SUBJECT: Forwards response to NRC 970313 RAI on pressurized thermal shock submittals for plant RV beltline mats per 10CFR50.61.

RE: St. Lucie Units 1 and 2  
Docket Nos. 50-335 and 50-389  
NRC TAC Nos. M95484 and M95485  
Request for Additional Information - Response  
10 CFR 50.61 - Pressurized Thermal Shock Evaluation

**Response to Nrc Supplemental  
Request for Additional Information  
St. Lucie Units 1 and 2  
Pressurized Thermal Shock Evaluation**

Figure 1: Plot of Weld Heat 305424 with Linde 1092 lot 3889 Baseline Charpy Data from the Beaver Valley Unit 1 Surveillance Program.

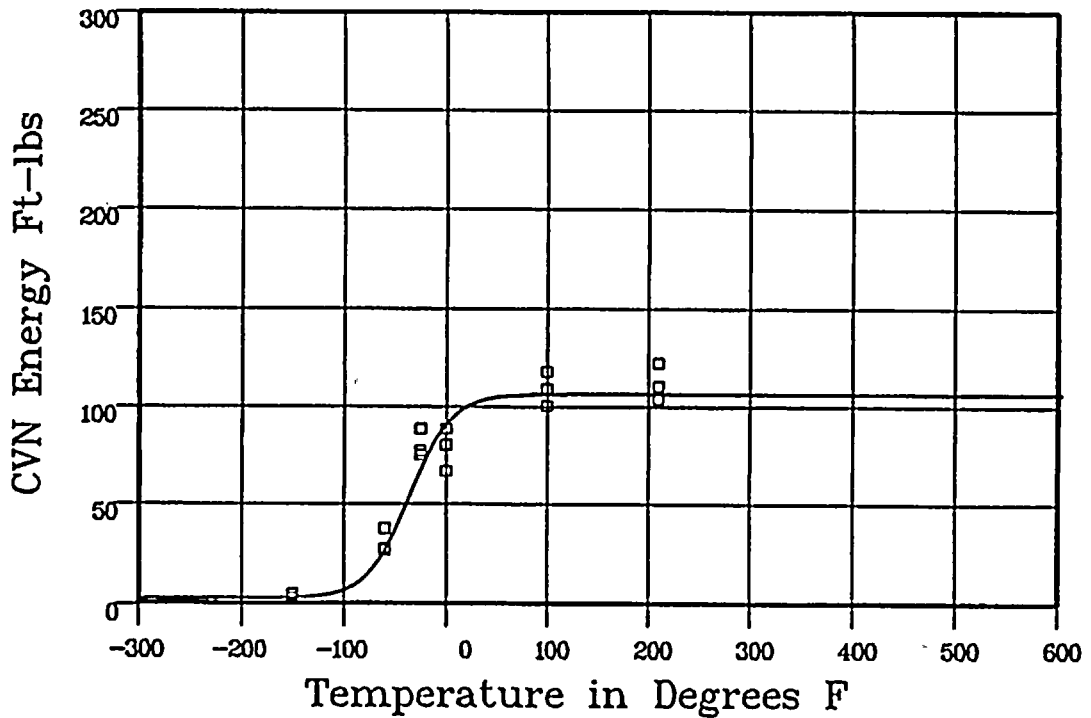
- a) The limiting weld in the St. Lucie 1 reactor vessel beltline is fabricated from weld wire heat 305424. This heat of weld wire was also used to fabricate the Beaver Valley 1 surveillance weld and welds in the LaSalle 1 reactor vessel beltline. The licensee's response 2 to the RAI indicated that the LaSalle and St. Lucie 1 Charpy data were not used to assess the  $RT_{NDT(U)}$  for the St. Lucie 1 vessel. Explain the effect on the value of  $RT_{NDT(U)}$  that would result from including the Charpy data from St. Lucie 1 and LaSalle 1. Verify whether the  $RT_{NDT(U)}$  value for heat 305424 remains drop weight controlled (i.e., does the lower bound Charpy curve become controlling).

The  $RT_{NDT(U)}$  was determined from drop weight test results of  $-60^{\circ}\text{F}$  NDTT and compared to a full Charpy curve from data produced as part of the initial property testing for The Beaver Valley Unit 1 (BV-1) surveillance program<sup>3</sup>. This was the only measured drop weight and complete Charpy data available for weld wire heat 305424 with Linde 1092 flux. This weld heat and flux combination was also used to fabricate the St. Lucie Unit 1 and LaSalle Unit 1 vessel beltline welds. Three Charpy tests were performed at  $+10^{\circ}\text{F}$  for the weld heat, 305424 with the same Linde 1092 flux, used to fabricate the St. Lucie Unit 1 and LaSalle Unit 1 vessel beltline welds. These three Charpy test data<sup>4</sup> of 82, 87, and 92 ft-lbs were reported (No lateral expansion or shear data was recorded) for both the St. Lucie Unit 1 and LaSalle Unit 1 vessel beltline welds. The available industry Charpy Data<sup>3,4</sup> for Heat 305424 is presented in the table below:

Figure 1 shows a plot of the 18 BV-1 baseline surveillance Charpy data points using a hyperbolic tangent curve fit. Figure 2 shows a plot of the 18 BV-1 baseline surveillance Charpy data points with the 3 Charpy tests at +10°F using a hyperbolic tangent curve fit. Comparison of these two graphs in Figures 1 and 2 show that the three +10°F Charpy data points; have little effect on the baseline surveillance data; are above a lower bound Charpy curve that would be drawn through 66.5 ft-lb data point at 0°F; and that at NDTT (60°F) plus 60°F, or 0°F, the drop weight temperature is still controlling for determination of  $RT_{NDT(U)}$  by meeting the not less than 50 ft-lb requirement of NB-2331.
